Item Name: Crosstube Turning Detail

DART AEROSPACE LTD	Work Order: 77306
Description: Crosstube Assembly (412 High Aft)	Part Number: D412-664-243
Inspection Dwg: D412-664-243 Rev: E	Page 1 of 1

DRAWING NO. D412-664-243	TITLE CROSSTUBE ASSEMBLY (412 HI AFT)	REV. E	DART AEROSPACE LTD ENGINEERING ORDER		D.E.O. NO. D412-664-243-E-1	SHEET NO. SHEET 1 OF 2	SCALE NTS
DRAWN	CHECKED	MFG. APPR.	APPROVED	DE APPR.			
DATE 11.03.31	DATE 11/03.31	DATE 11.03.31	DATE 11/03.31	DATE 11.03.31

DRAWING NO. D412-664-243	TITLE CROSSTUBE ASS'Y (412 HI AFT)	REV. E	DART AEROSPACE LTD ENGINEERING ORDER		D.E.O. NO. D412-664-243-E-2	SHEET NO. SHEET 1 OF 1	SCALE NTS
DRAWN 92	CHECKED AS	MFG. APPR. E	APPROVED MP		DE APPR. H		
DATE 11.09.07	DATE 11.09.19	DATE 11.09.19	DATE 11.09.19		DATE 11.09.19

D212-664-243
ASSEMBLY DETAIL E

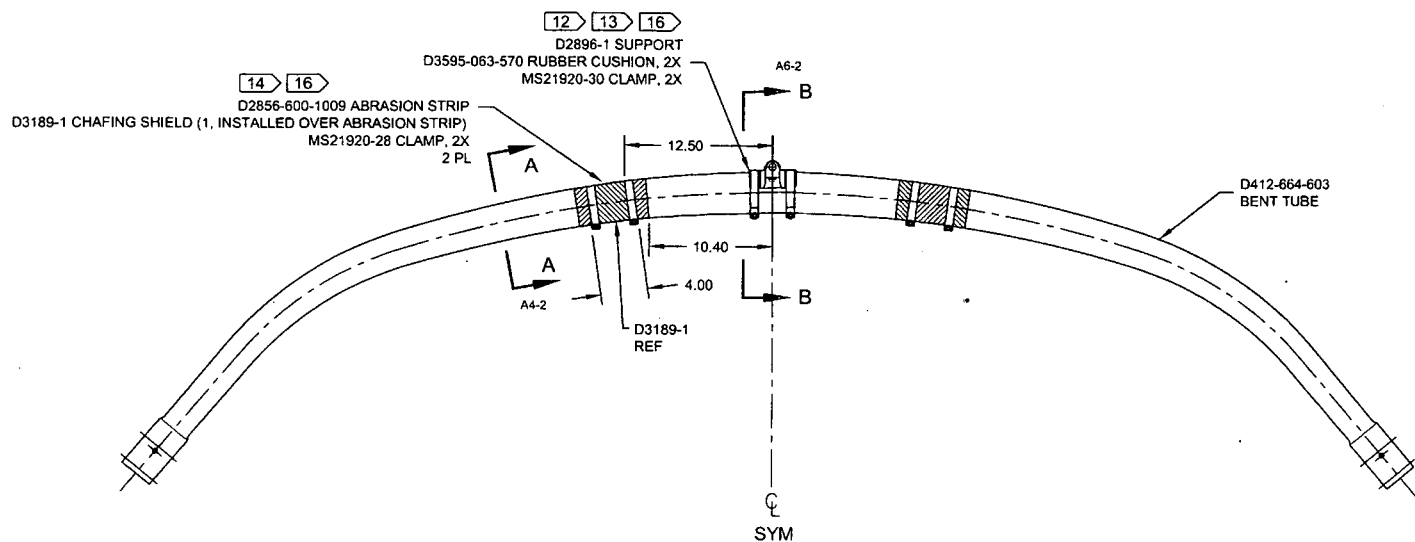
E	REFORMAT/REVISE GENERAL NOTES; REORGANIZED VIEWS AND REFORMATTED DRAWING TO CURRENT STANDARDS; RELOCATED FLAG #6 PER PAR 08-046 (ZN A6-3); ADD TOLERANCE (ZN B6-3, C4-3, C8-3 & C5-3); MOVED TURNING DETAIL & UPDATED TOLERANCE TO SHEET 4.	RF	09.09.30
D	REMOVE D2732-058, CHANGE TO D3595-063-570	PH	07.03.09
C	REMOVE D2856-600-1087, ADD D2732-058 & MAGNOBOND 6398, MS21920-32 WAS MS21920-30	MB	06.10.27
B	ADD HOLES FOR COMPATABILITY WITH BHT/AA SKID TUBES	PH	05.02.04
A	NEW ISSUE	PH	01.10.17
REV.	DESCRIPTION	BY	DATE
DESIGN	PH	DART AEROSPACE LTD	
DRAWN	RF	HAWKESBURY, ONTARIO, CANADA	
CHECKED	PH	DRAWING NO.	REV. E
MFG. APPR.	PH	D412-664-243	SHEET 1 OF 4
APPROVED	PH	TITLE	SCALE
DE APPR.	PH	CROSSTUBE ASSEMBLY (412 HI AFT)	NTS
DATE	09.09.30	COPYRIGHT © 2001 BY DART AEROSPACE LTD THIS DOCUMENT IS PRIVATE AND CONFIDENTIAL AND IS SUPPLIED ON THE EXPRESS CONDITION THAT IT IS NOT TO BE USED FOR ANY PURPOSE OR COPIED OR COMMUNICATED TO ANY OTHER PERSON WITHOUT WRITTEN PERMISSION FROM DART AEROSPACE LTD.
